Re: Phillips Ave Shared Path

Bicycle NSW wishes to thank the Canterbury Bankstown City for the opportunity to comment on the Phillips Avenue Shared Path.

Figure 3.5 Typical cross section - constrained configuration (12.8m carriageway)

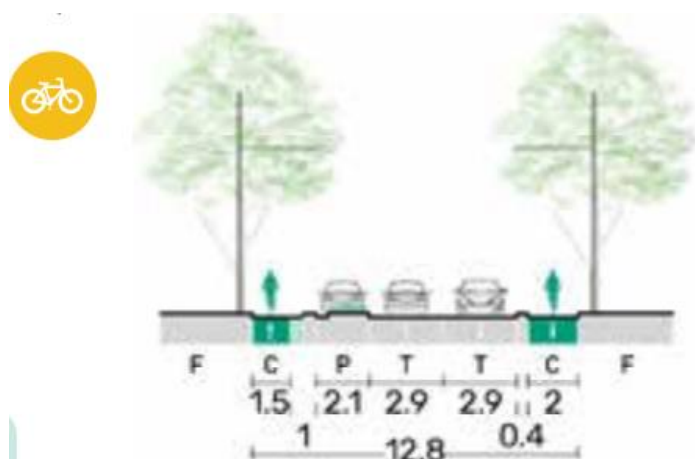
Bicycle NSW recommends that Canterbury Bankstown City explore options such as a separated bicycle path. Given Phillips Avenue is the standard 12.8 M wide, then there is ample space for a separated bi-directional cycleway protected from road traffic by parked cars. Whilst we support the

reduction of parking spaces due to the waste of public space and negative impacts upon active transport, in this case, it may not be needed. Advantages of utilising spare road space for separated cycleways include:

- Safety for pedestrians who no longer have to worry about conflict with bicycle riders.
- Improved access and safety for bike riders.
- A filtering and narrowing of the local road network necessitating slower traffic speeds. This further increases the safety of pedestrians and cyclists, many of whom would be children and families.
